ULPOWER AERO ENGINES N.V.

SERVICE BULLETIN

Service Bulletin No. 2021-02

SUBJECT: Selection of correct channel on TPS sender

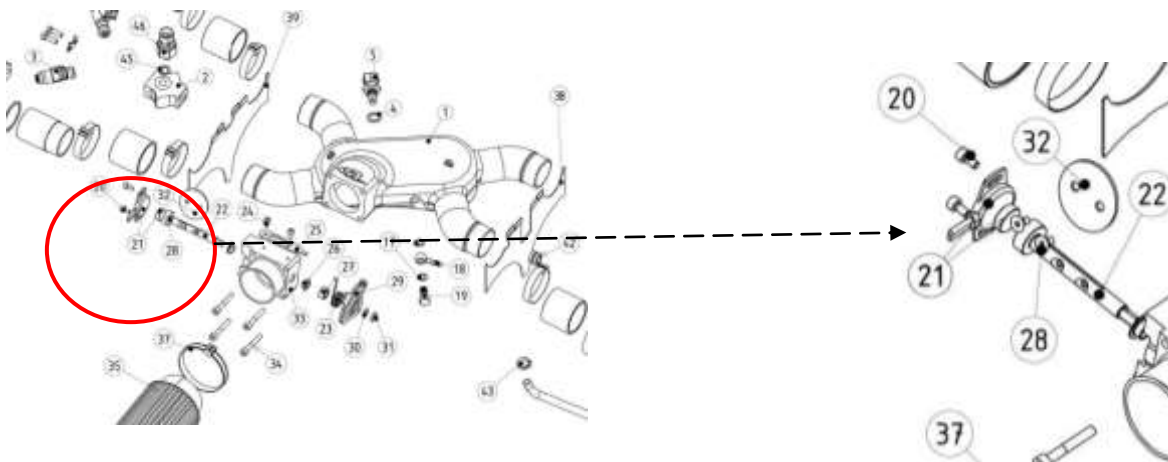
Field reports and experience has shown that the dual TPS sender (E081506 – part 21 in the drawing below) MUST be connected to channel 1. (CH1)
Connection to channel 2 (CH2) , may under exceptional circumstances , lead to interrupted or incorrect data flow to the ECU and possible improper engine behavior.

The design /internal structure of channel 1 (CH1) is different from that of channel 2. Therefore, it is mandatory to check if the engine wiring loom is connected to CH1. If this is not the case, it is necessary to unplug the engine wiring loom connector from CH2 and plug it into CH1 before next flight

The image below shows the type of TPS [E081506] to which this service bulletin applies (manufacturer code NRH285DR).

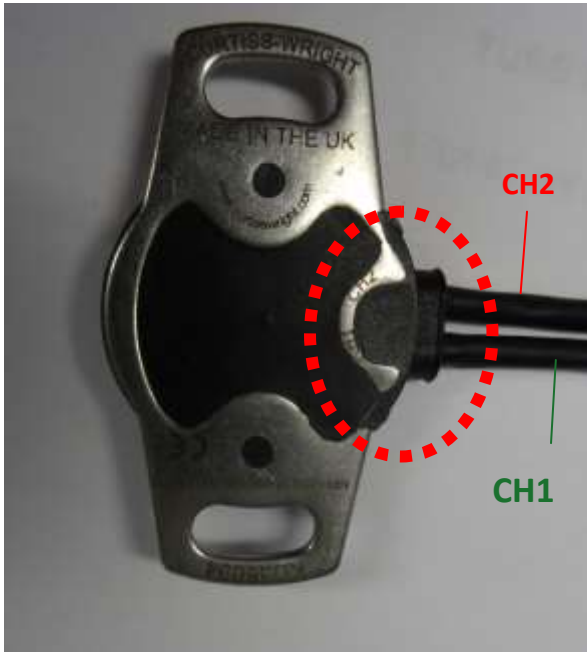
On the TPS you will see the designation CH1 (Channel 1) and CH2 (Channel 2) with the respective cable.

Do not remove the TPS from the throttle body if the designation isn't easily visible !

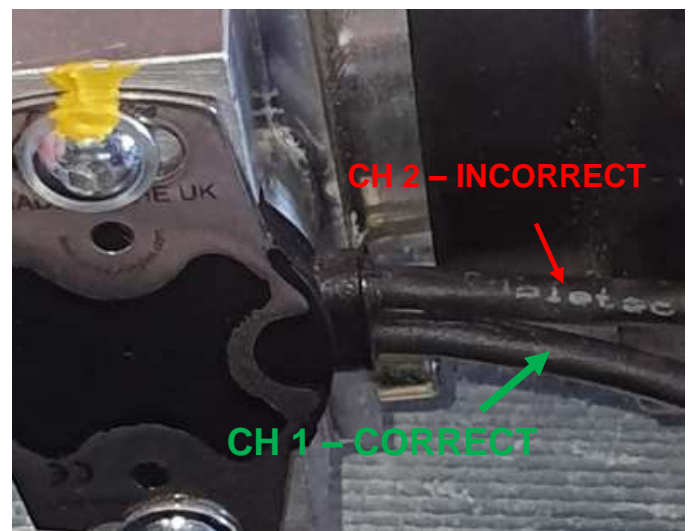
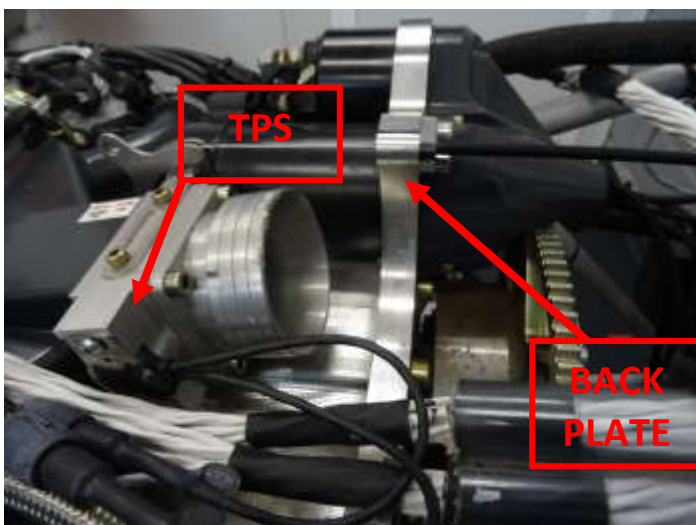
Usually the TPS is orientated in a way that the cables point in the direction of the engine back plate, If this is the case CH1 is the LOWER cable. (see pictures below)

1. Check which channel is connected to the cockpit wiring loom. If CH1 = OK. If CH2 is connected, follow the steps below.

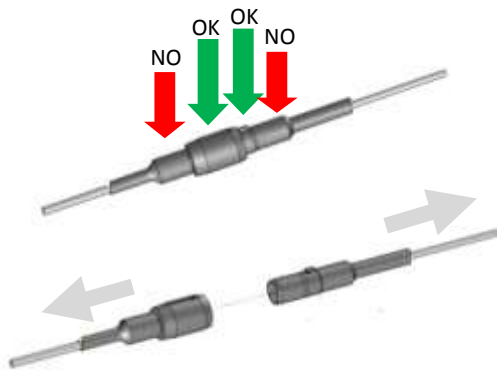
- Disconnect the TPS from wiring loom by pulling on the **connector**, not the **heat shrink**

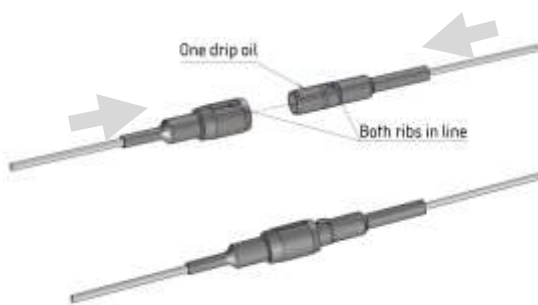
- Locate (CH1) and connect it to the engine wiring loom . Apply one drip of oil on the rubber of the male connector (engine wiring loom) and insure that the ribs are aligned before pushing fully into to female connector.

- Carry out appropriate, full-range (idle to full power) engine tests on the ground before further flight.
